Appellant letter - Heal the Ocean

**RE: BOS 12/10/2024 Hearing Agenda Item #5 - Miramar Hotel Appeal**

## MEMORANDUM

**To:** Hillary Hauser and Noah Boland, Heal the Ocean  
**From:** Paul Wisniewski, Jeff Davis, Integral Consulting Inc.  
**Date:** 12/06/2024  
**Subject:** Proposed Miramar Resort Development  
**Project No.:** C4331

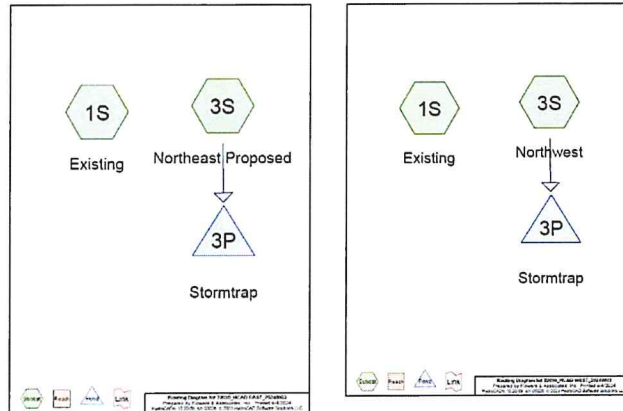
- ii. The model shows different drainage areas than those discussed in the text of the report. Specifically, the text describes drainage management areas (DMAs or subcatchments) that are not shown in the model. The model fails to define the extent of the DMAs. Further, the model does not define or show DMAs in the report or drawings, preventing reliable interpretation of the model parameters or outputs.

See excerpts below from page 4 of the Preliminary Drainage Report text and HydroCAD hydrology calculations from Appendix A:

**Subcatchment 1S: Existing**

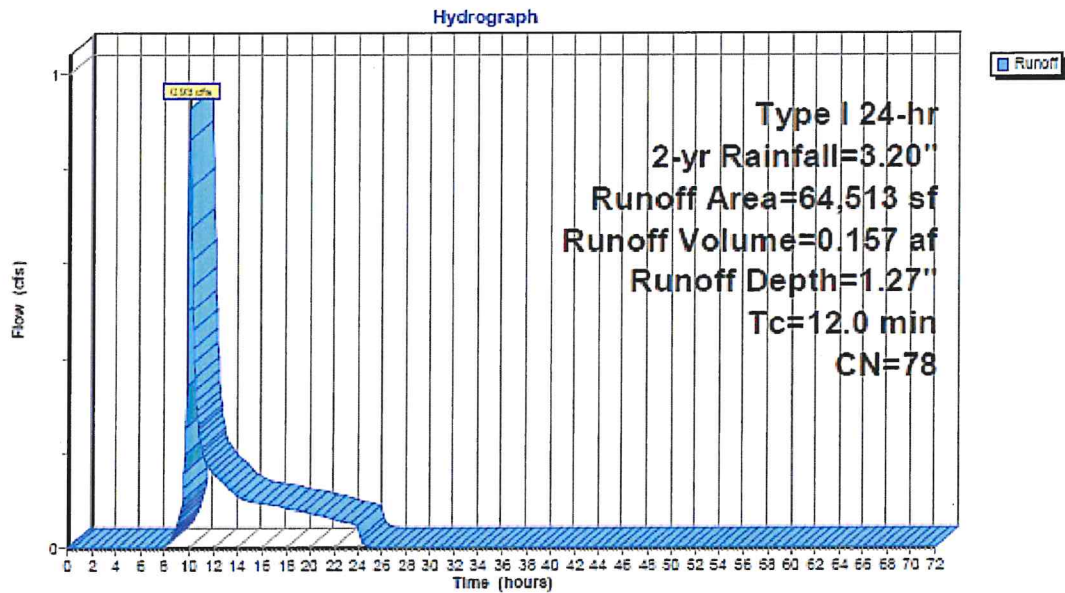
- b. The HydroCAD model is flawed:
- Time of Concentration ( $T_c$ ) for pre- versus post-project is unchanged in the model, and unlikely representative of actual conditions (e.g., 12.0 minutes  $T_c$ ). Further, no additional data are provided to show the stormwater flow path (e.g., sheet flow, shallow concentrated flow, etc.).

- Insufficient model output or metadata to evaluate various model parameters. For example, the report fails to define or show subcatchment areas.
  - Each DMA should include a separate  $T_c$  and its own pervious/impervious calculations in detail in the model and as discussed in the text but fails to do so.

- The model uses hydraulic soil group A, which is much less conservative than group B, which is indicated for use at the site per the USDA Web Soil Survey (<https://websoilsurvey.nrcs.usda.gov/app/>). The resulting higher curve numbers (dimensionless parameters to estimate the amount of runoff) for group A soil that were used in the model resulted in lower discharge values that are not representative for the site. See below the yellow-highlighted values in one of the HydroCAD Hydrology Calculation forms for the Northeast Lot, excerpted from Appendix A.
